Report Of The CSCC Meeting - February 3, 2016

CSCC 16-01. Berm & Plantings Within Scenic Corridor, 5314

MEMORANDUM

RE: February 3, 2016 - MEETING ISSUE REVIEW

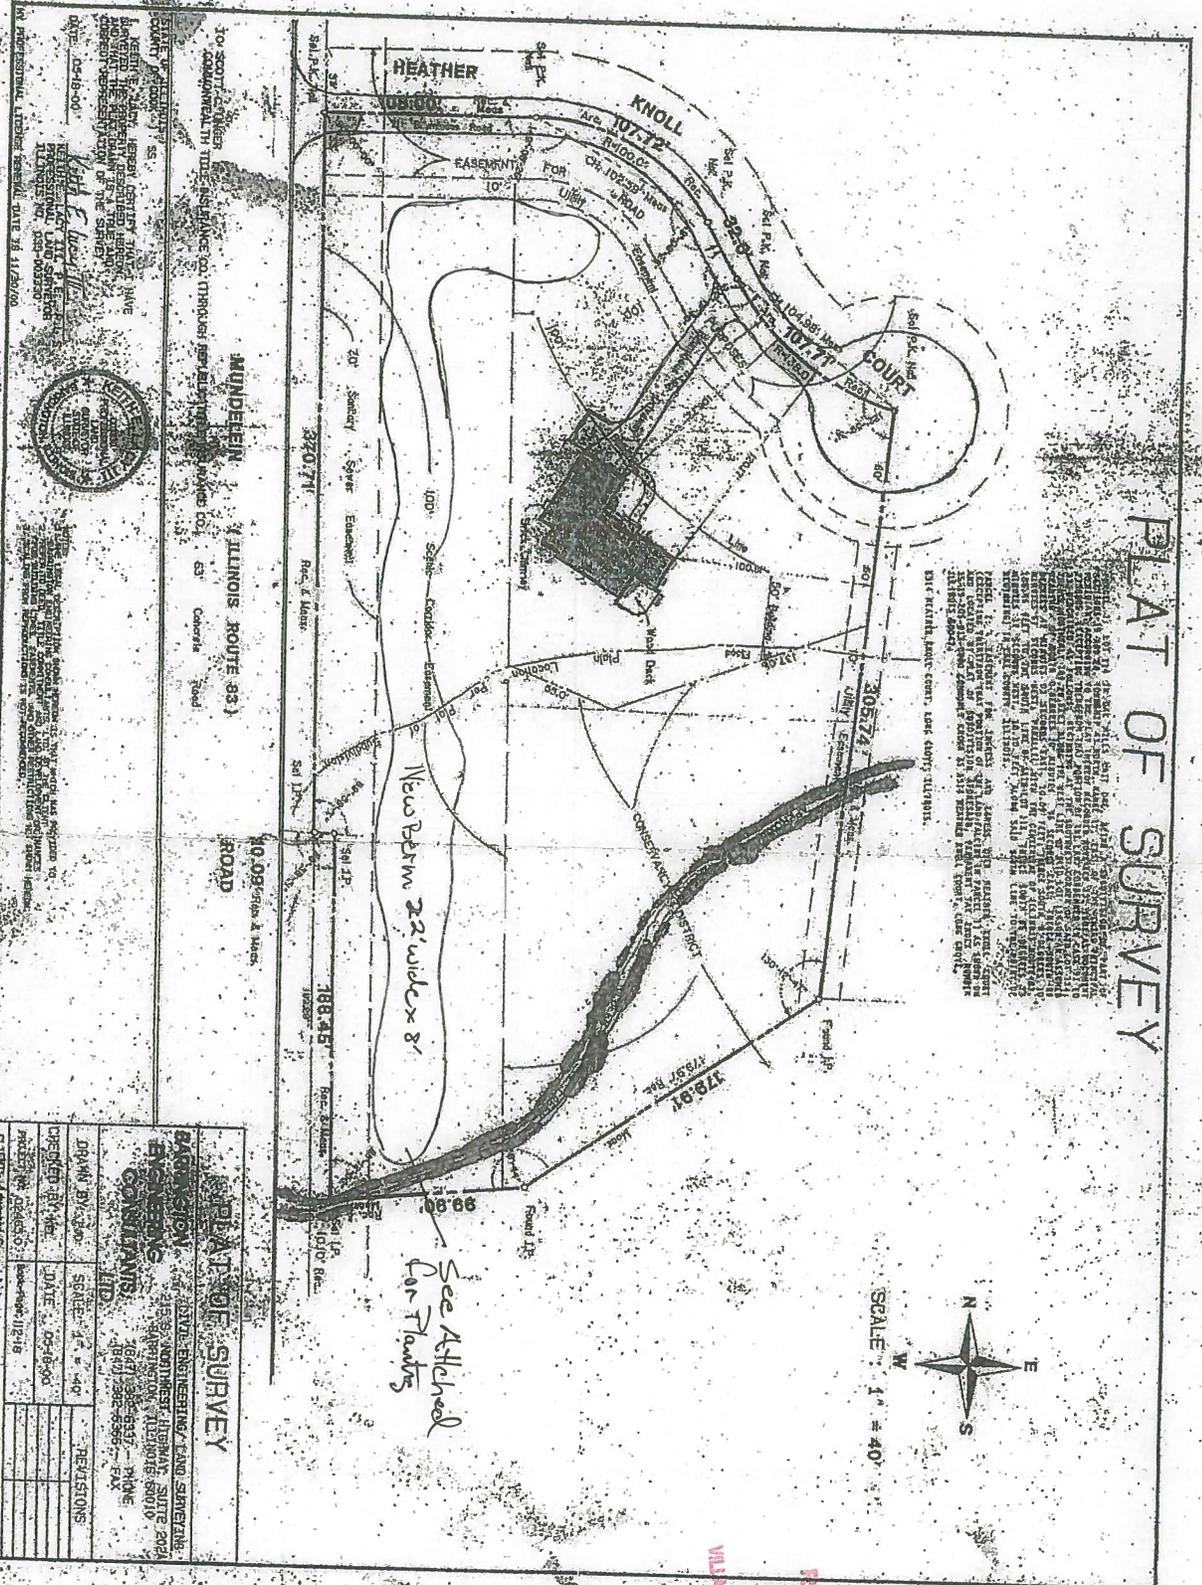
~~280~~ 558 lft x 28 = 15,624 ~~ft~~ ÷ 4,000 = 3.9 (4)

Uiburnums
off list

- need plants
- 12 - 3" ^{Native} Hardwood canopy trees
 - 12 - 2" Hardwood canopy trees
 - 8 - 1 1/2" - under story/ornamental trees
 - 60 - 3' shrubs

PLAT OF SURVEY

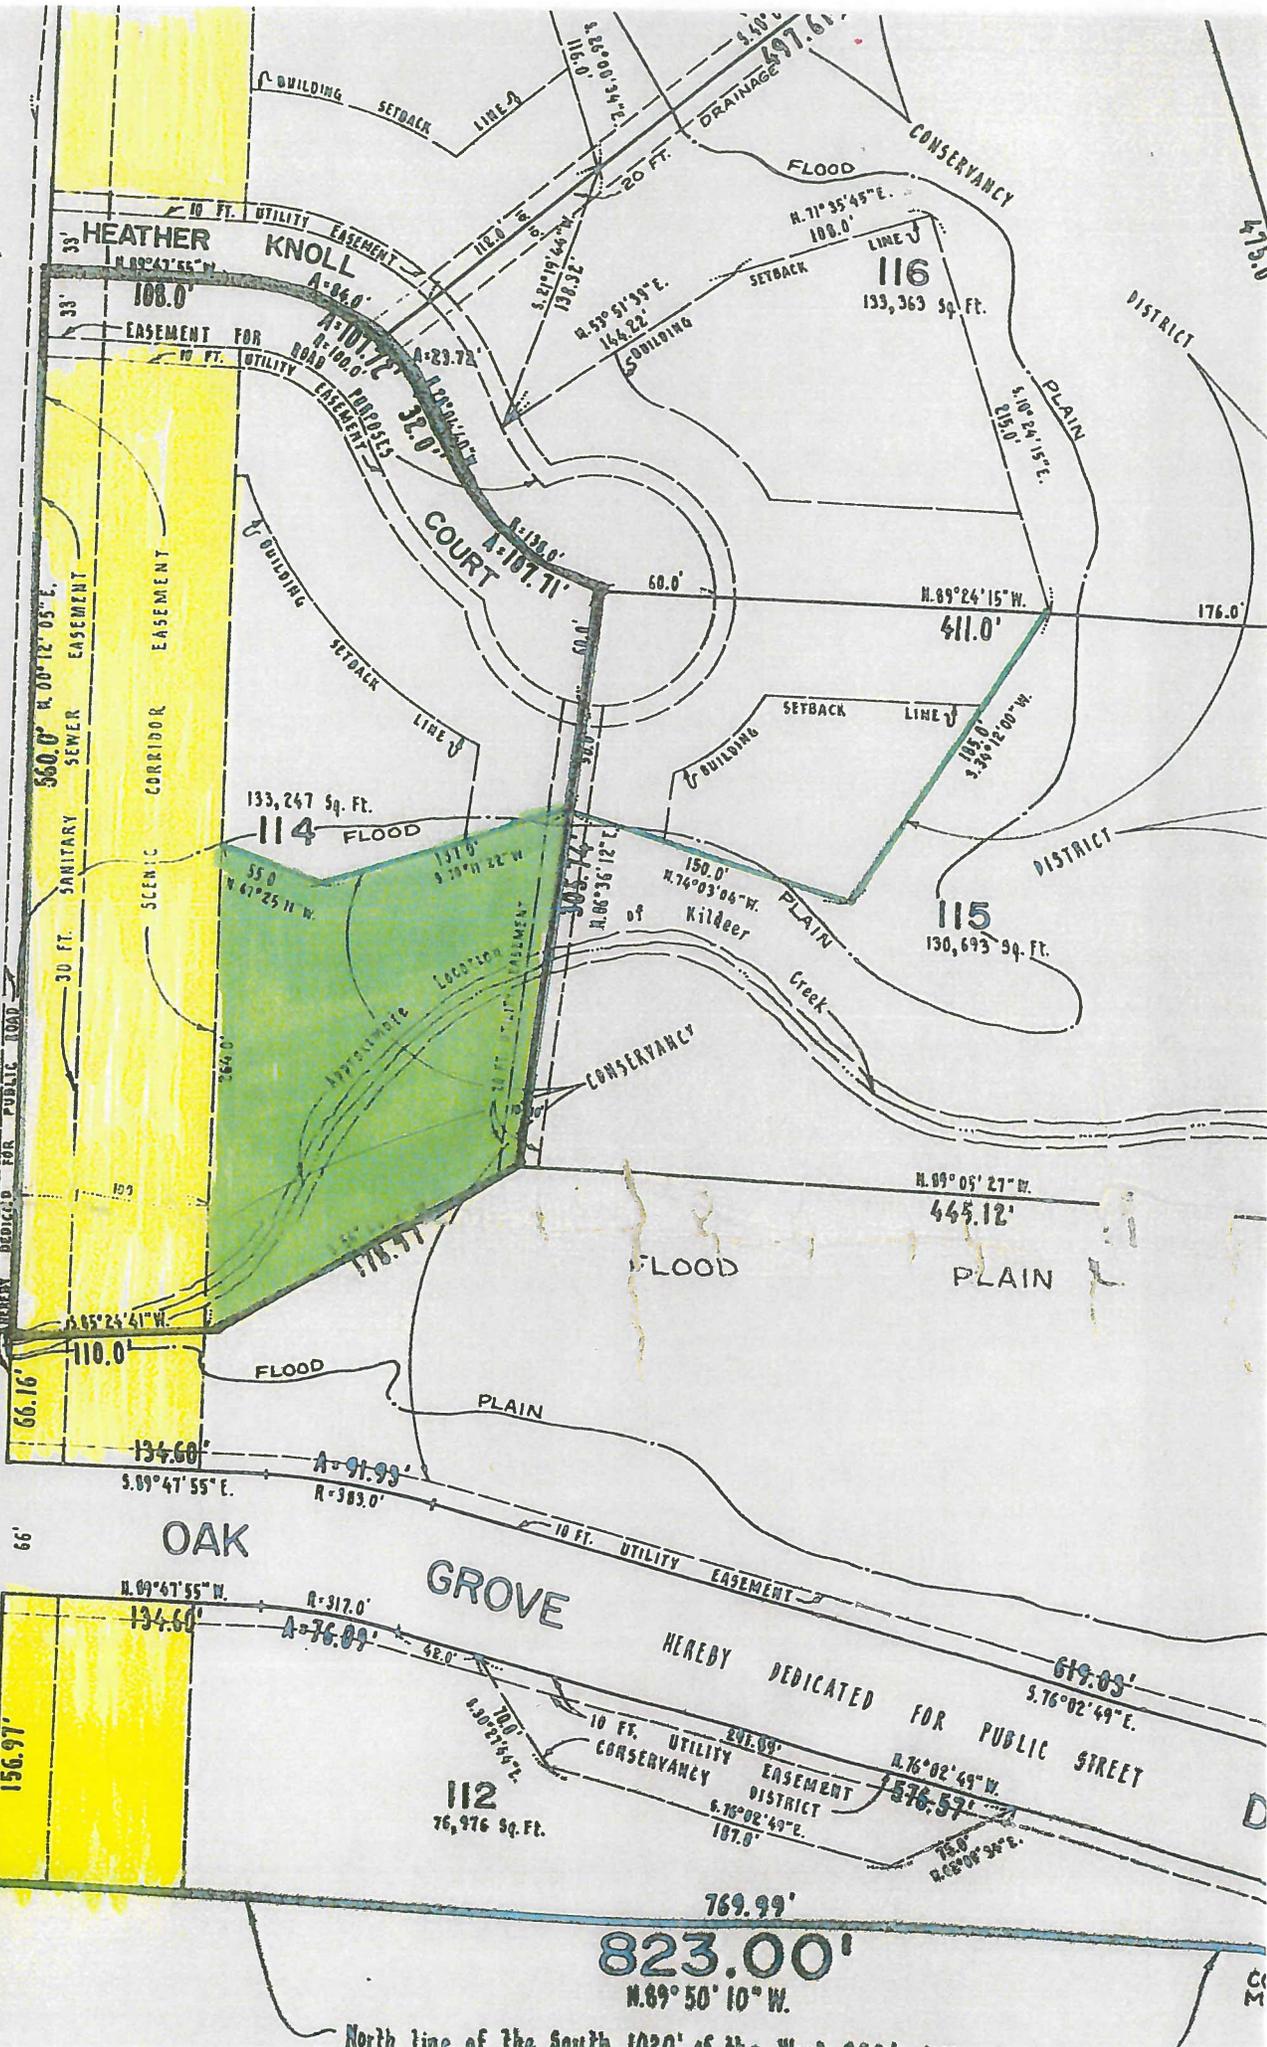
The berm is being requested by the purchaser of the property to provide a barrier between the residence and traffic on Route 83. As proposed the berm would measure 22' wide by 560 feet

long and 8' high. The berm would run along the western property line of the subject property abutting Route 83. The berm as proposed would encroach into both wetlands and floodplain along the south 240 (+/-) feet of the subject property.

As proposed the berm appears to conform to the standards for berms as identified in the subdivision code, however, in this instance no subdivision of property is occurring. The berm will have a height of 8 feet, the slope of the berm facing the street is less than 20% and the steepest slope of the berm faces away from the roadway. A berm along Route 83 could be constructed to a height of greater than 8 feet as noted above.

The CSCC should acknowledge the conformance of the berm to the applicable standards fo the Village Code and determine the appropriate planting mix for the berm. The afforestation schedule listed above (paragraph C) appears to apply as the entire square footage of the berm is greater than 4000 square feet. Nonnative flowering plants & evergreen species may be utilized subject to CSCC review and approval. Screening and buffering of the residence should be the primary consideration for plantings within the Scenic Corridor.
